SERVICE DIRECTIVE BULLETIN

Service Directive Bulletin No. 0058
Page 1 of 5

Subject: Removal of the Induction Pressure Relief Valve

Models: F-28C, F-28C-2 and 280C

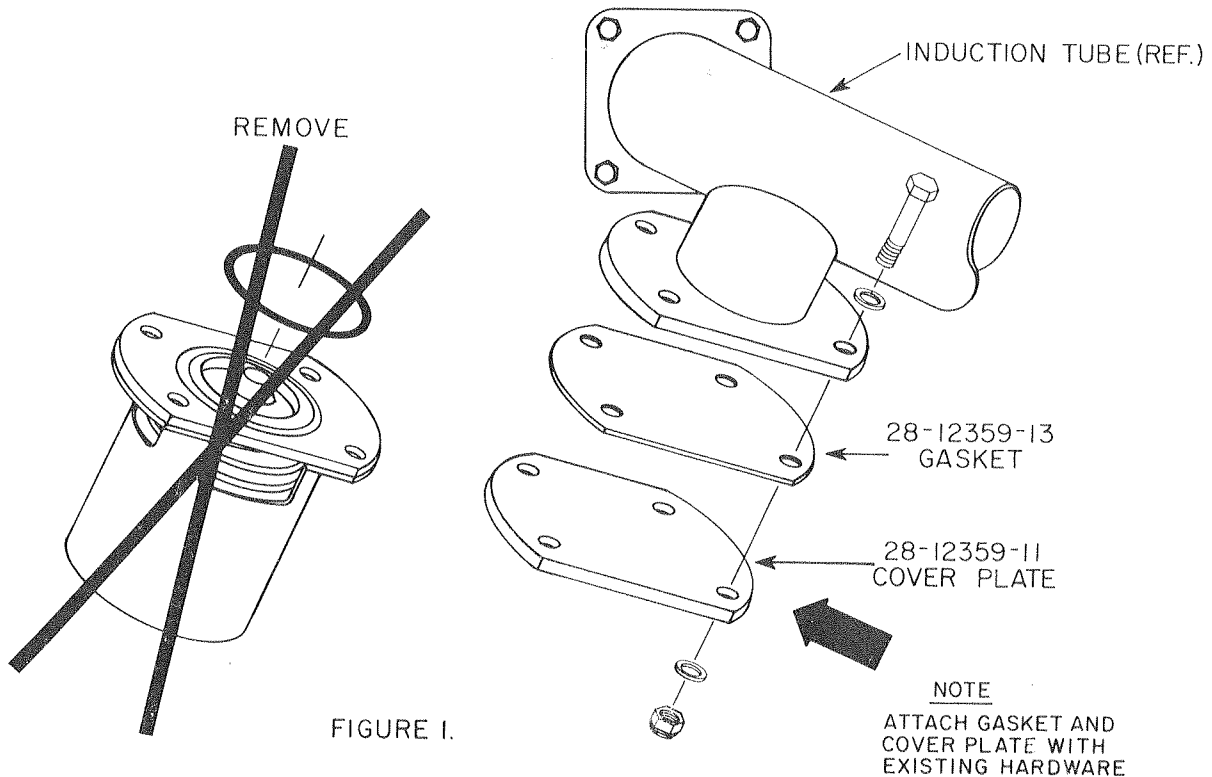
To incorporate the modification refer to Figure 1 to remove pop-off valve and cover the resulting induction tube opening. Figures 2 thru 4 detail the installation of the pressure switch, overboost caution light, and the related electrical connections.
